RE: 8701 Glendale Ave. NE
Grading & Drainage Plan
Engineer's Stamp Date: 07/23/24
Hydrology File: B20D069

Based upon the information provided in your submittal received 08/21/2024, the Grading & Drainage Plan **is not** approved for Grading Permit. The following comments need to be addressed for approval of the above referenced project:

Grading & Drainage Plan

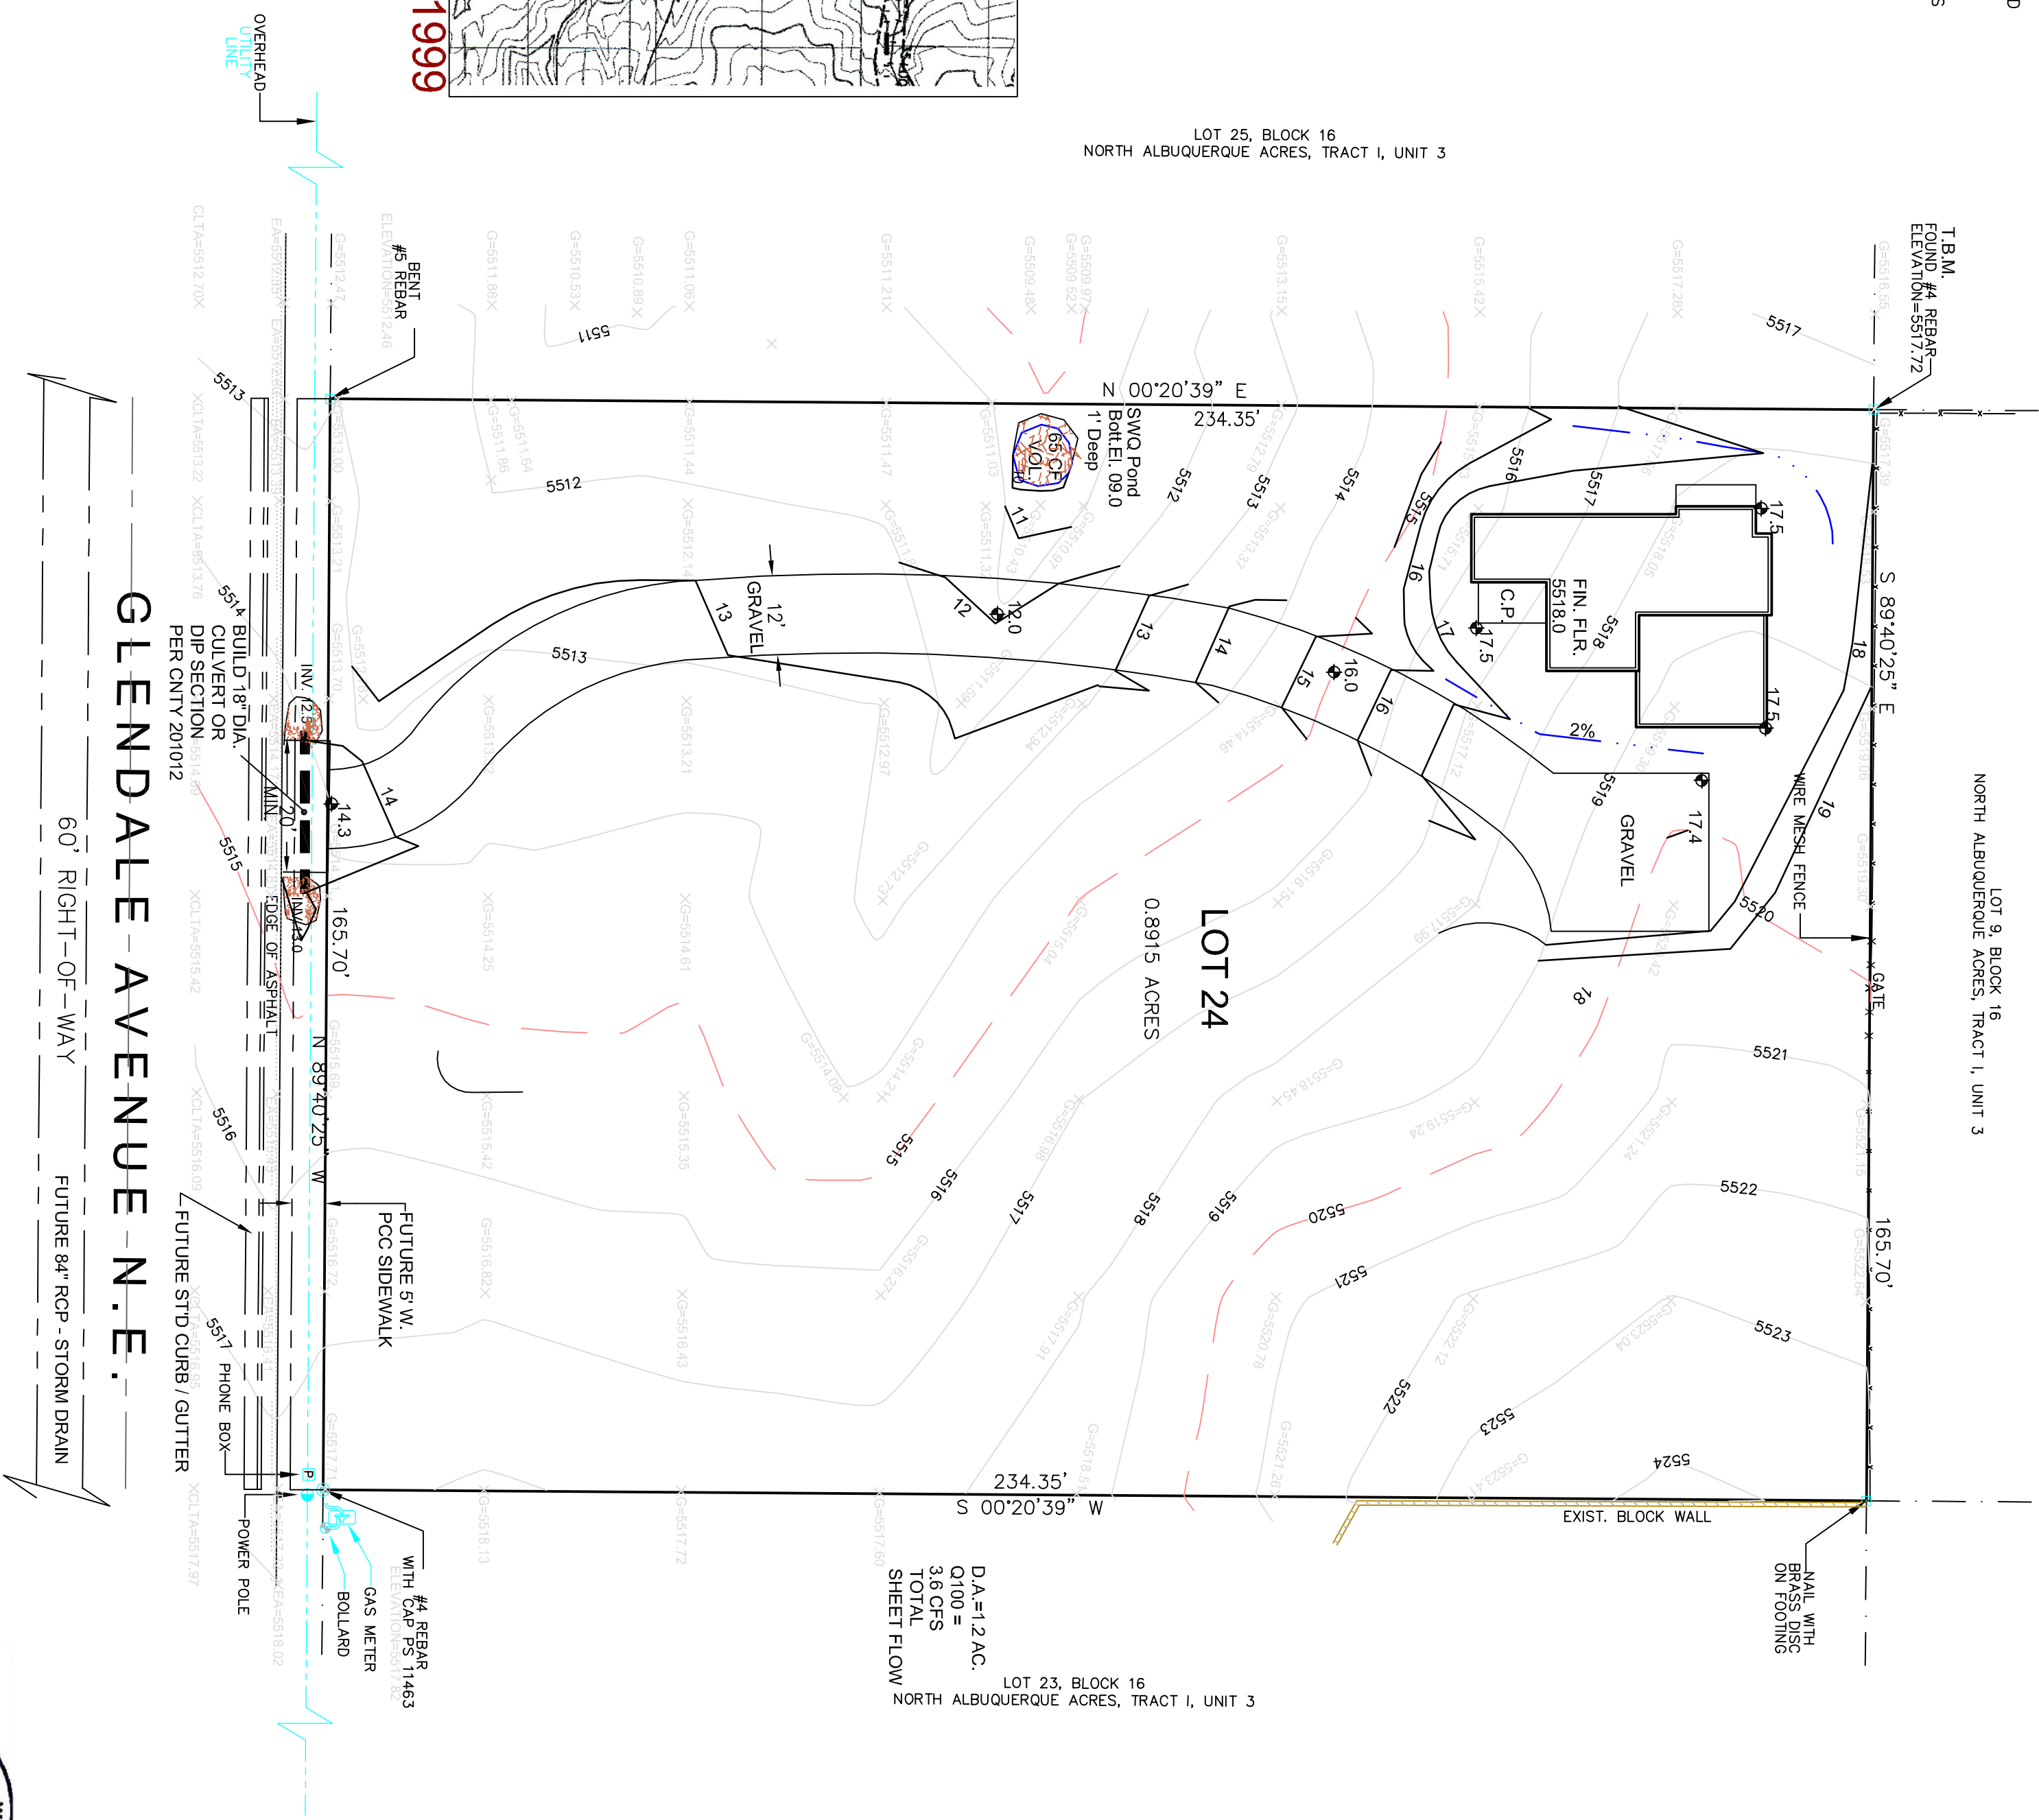
1. Per the IDO, the property owner of the property is responsible for building the adjacent half of Glendale Ave. NE to include curb & gutter, and sidewalk. The project will have to go to the Development Facilitation Team (DFT) for approval of the Infrastructure List. Also, half of an 84" storm sewer (see below) will also need to be added to the Infrastructure List. The storm sewer was called out in the NAA MDP.

2. These improvements will need to be shown on the Grading & Drainage Plan.
3. Please insert a cross-section showing the ROW limit, proposed sidewalk, C&G and the driveway culvert location. Driveway culvert can't be under sidewalk.

4. Properly showing and calculating the existing drainage that goes in the natural arroyo and Glendale from the east to the west needs to be done. This existing drainage needs to be allowed to go through the property and can be managed somehow in the proposed development.
